November 22, 2024

Re: Docket No. 508 - The United Illuminating Company Application for a Certificate of Environmental Compatibility and Public Need for the Milvon to West River Railroad Transmission Line 115-kV Rebuild Project – Notice of Additional Laydown Area

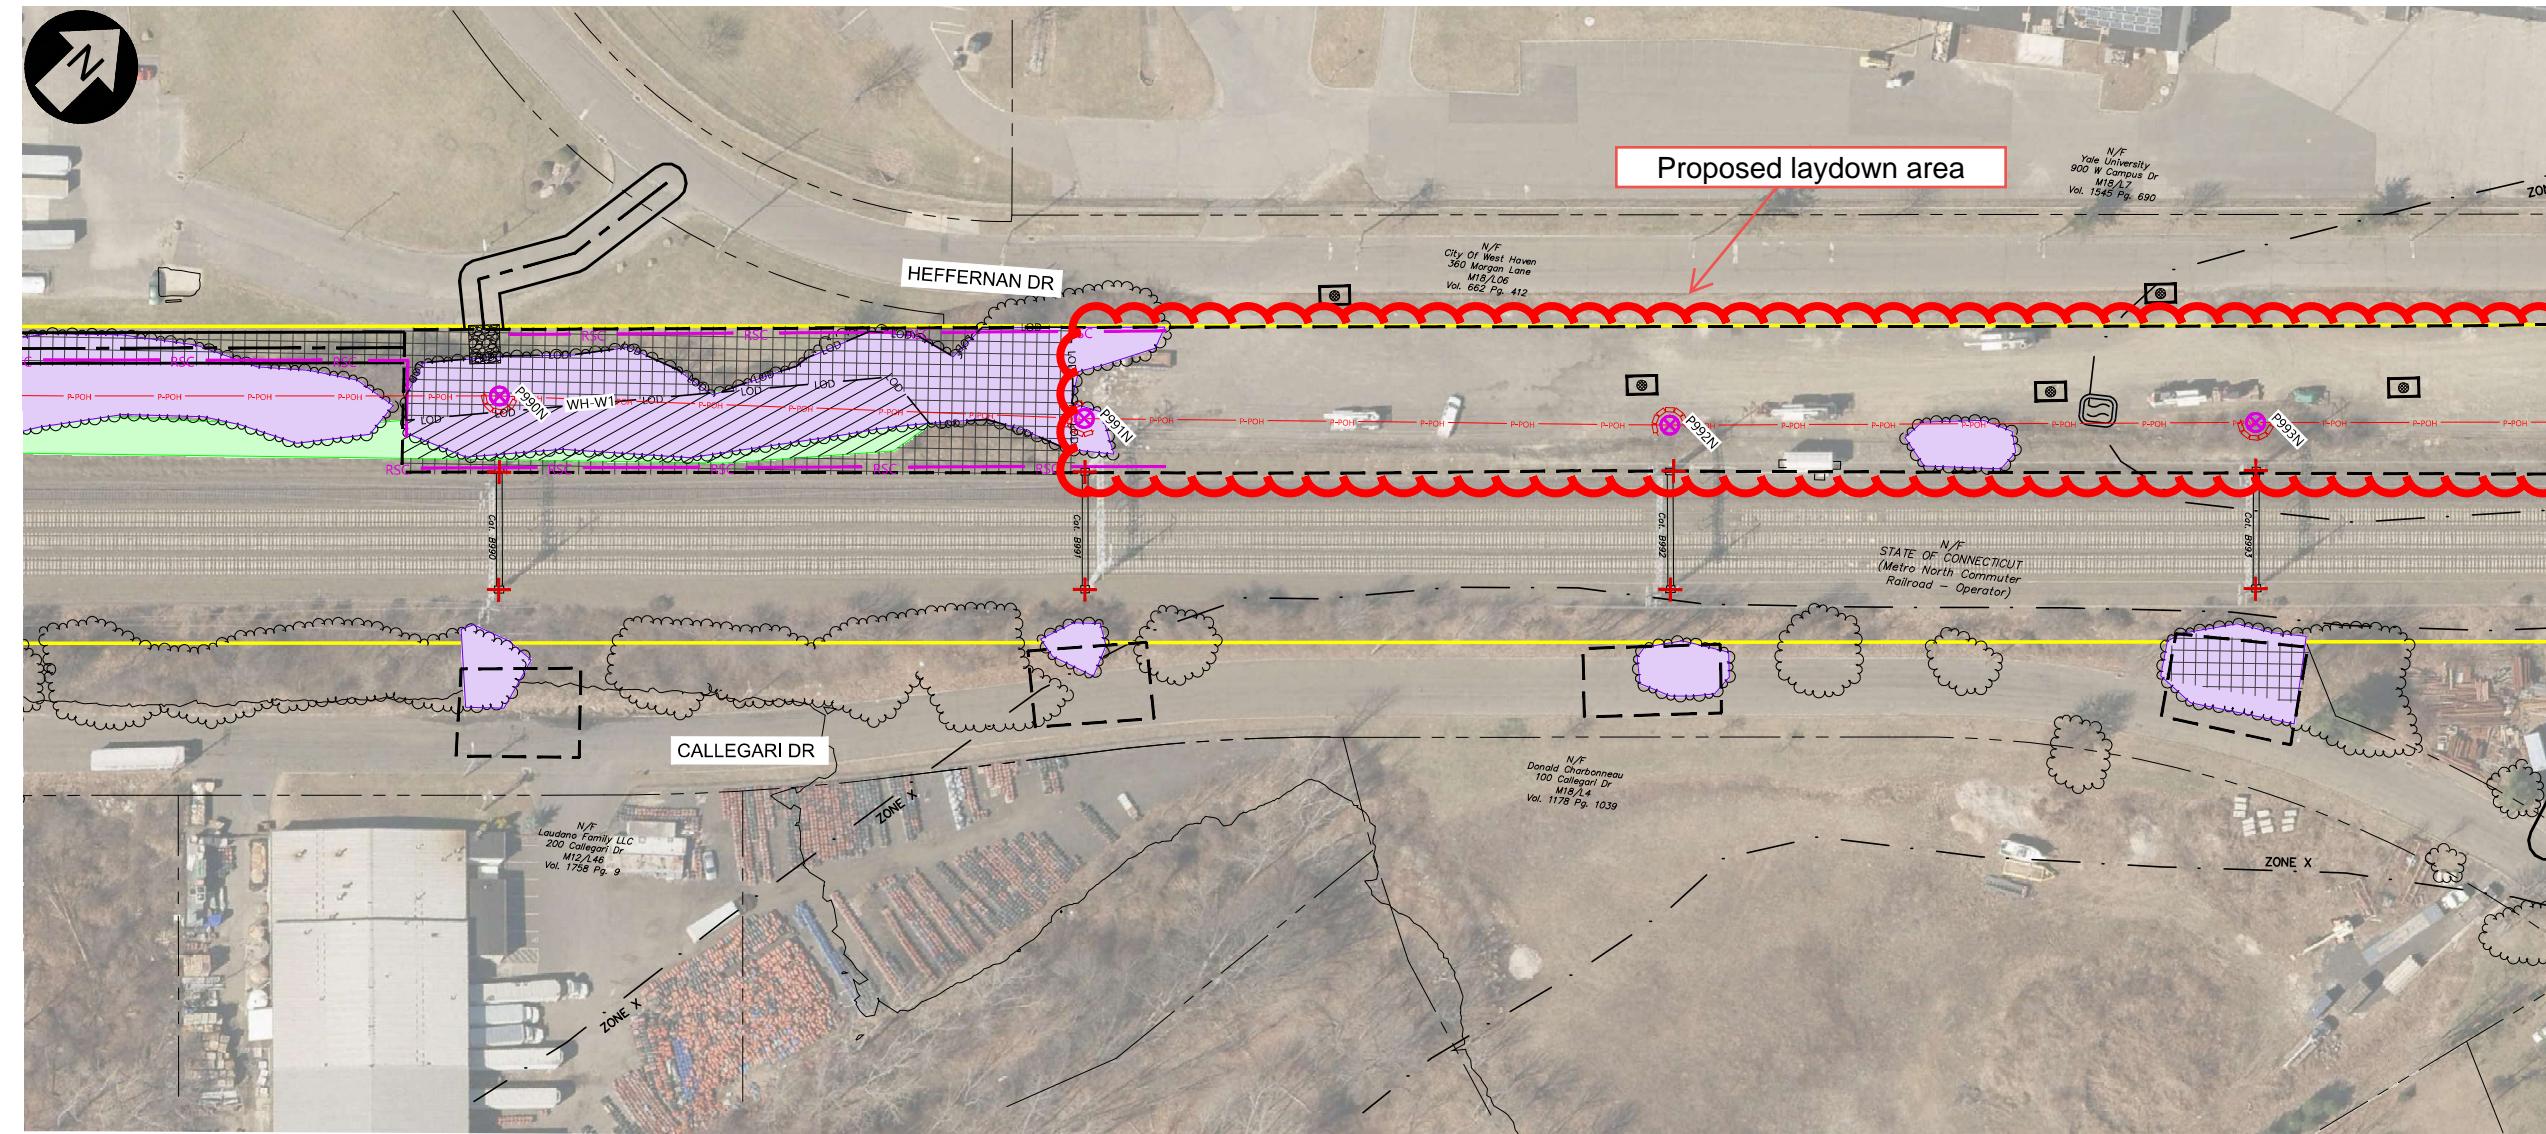
Pursuant to the Regulations of Connecticut State Agencies Section 16-50j-62(b)(2) and Attachment M to the Project's Development & Management Plan (approved June 8, 2023), The United Illuminating Company ("UI") notifies the Council that an additional construction laydown area for the Project will be located along Heffernan Drive in West Haven, between structures P991N and P994N. The laydown area is shown on the attached image.

- The installation and maintenance of silt sock around the perimeter of the property, as needed.
- The installation and maintenance of inlet protection for all drainage on-site.
- Equipment brought to and stored at the laydown area will be cleaned free of invasive species prior to mobilization from project sites.
